#2026-129
ComEd Facility (5100 S Illinois Route 31)–Special Use Permit Amendment with Variations
Project Review for Planning and Zoning Commission

Meeting Date: August 19, 2026

Request: Special Use Permit Amendment to allow improvements to the existing ComEd office and maintenance yard facility, including Variations for:

1 **MASTER SITE PLAN**
1" = 30'-0"
0

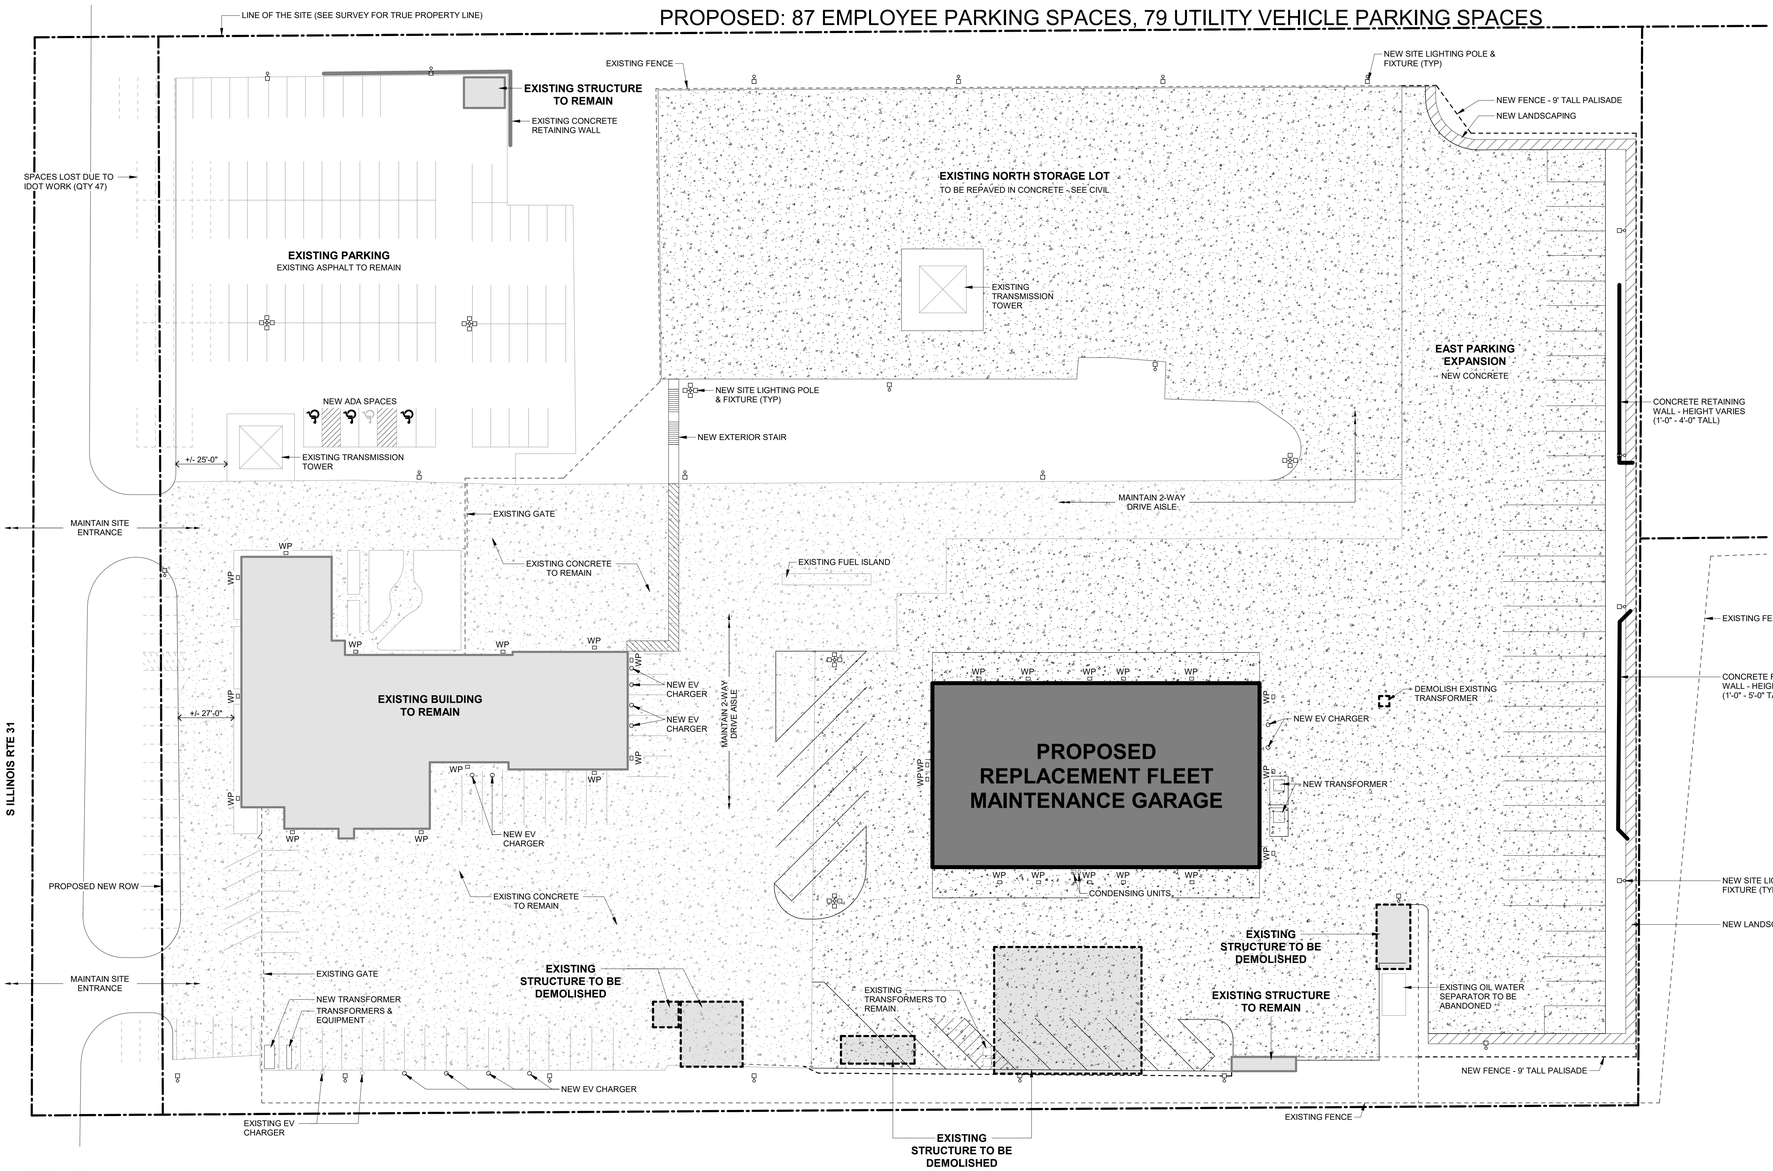
- **New maintenance garage**
  - This 22,000-square-foot building will replace an existing garage to provide fleet maintenance and to allow for the indoor repair and testing of ComEd bucket trucks. The height of the garage (65 feet) will allow full extension of the vehicle booms indoors. This building will be erected towards the rear of the property, nearly 400 feet from the front property line.

- **Reconfigured parking and storage areas**
    - Primarily to accommodate the new building, additional parking and vehicle storage will be added onto the east side of the existing parking and storage areas.

- The northern edge of the parking area is about 73 feet from the south property line of the neighboring townhomes.
    - Perimeter landscaping will be planted around the edges of the extended parking area. Arbor vitae, capable of reaching 15 feet in height, will line the northern edge to provide additional screening for the townhomes.

- The reconfiguration will reduce the number of employee parking spaces from 135 to 87, but this is still more than the spaces needed for a typical peak shift, which has approximately 60 employees.

- Underground detention will be created beneath the new impervious surface area to handle the stormwater runoff. This design has been conceptually approved by the City Engineer.

1. Project plans shall be consistent with the information and testimony provided by the petitioner in the hearing and the following provided documents:
   A. Application/Narrative (Sidley Austin LLP, received 07/01/26)
   B. Site Plan (Wold, undated, received 07/09/26)
   C. Architectural Plans/Renderings (Wold, dated 6/24/26, received 07/09/26)
   D. Preliminary Engineering Plans (MeritCorp, dated 06/25/26, received 07/09/26)
   E. Preliminary Stormwater Report (MeritCorp, dated 06/25/26, received 07/09/26)
   F. Landscape Plan (Design Perspectives, dated 07/09/26, received 07/09/26)
   G. Lighting Plan (Unnamed, undated, received 07/09/26)

EXTERIOR ELEVATIONS

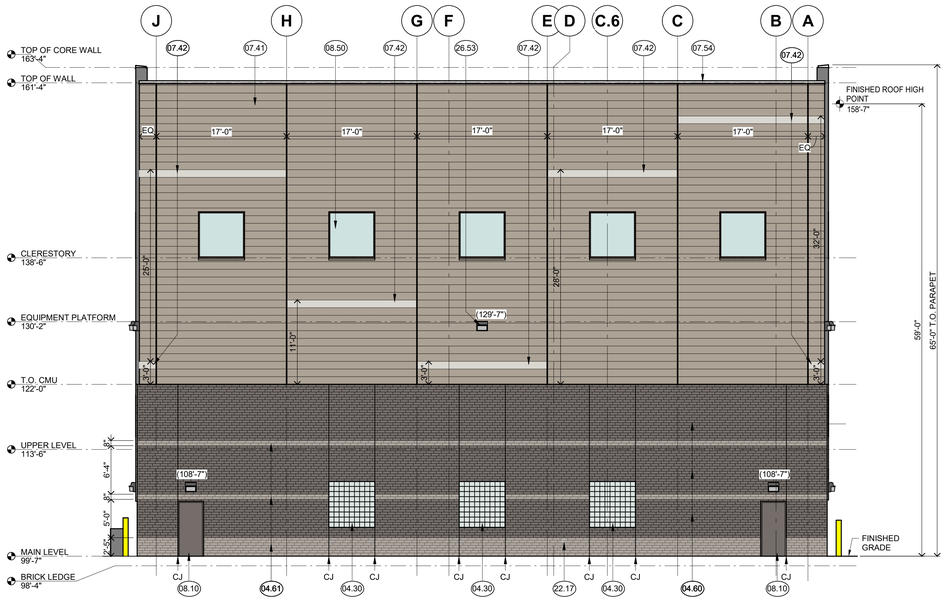
- Based on the definition of 'height' in the UDO, the flat-roofed building is 65 feet, due to the parapet walls extending higher than the flat roof.
  - The building can meet the minimum standards in the UDO for industrial buildings by adding a defined top to the parapet. It features variations in colors, materials, and horizontal and vertical planes.

- **<u>Garage</u>: height variation of 65 feet instead of the maximum allowed 25 feet for accessory structures.**
  - The applicant has stated that this height is necessary for the indoor testing and repair of fleet vehicles with boom lifts.
- **<u>Fence</u>: height variation of 9 feet, instead of the maximum allowed 6 feet.**

3. Add a defined top to the parapet walls or propose another solution to meet the design standards for industrial buildings.
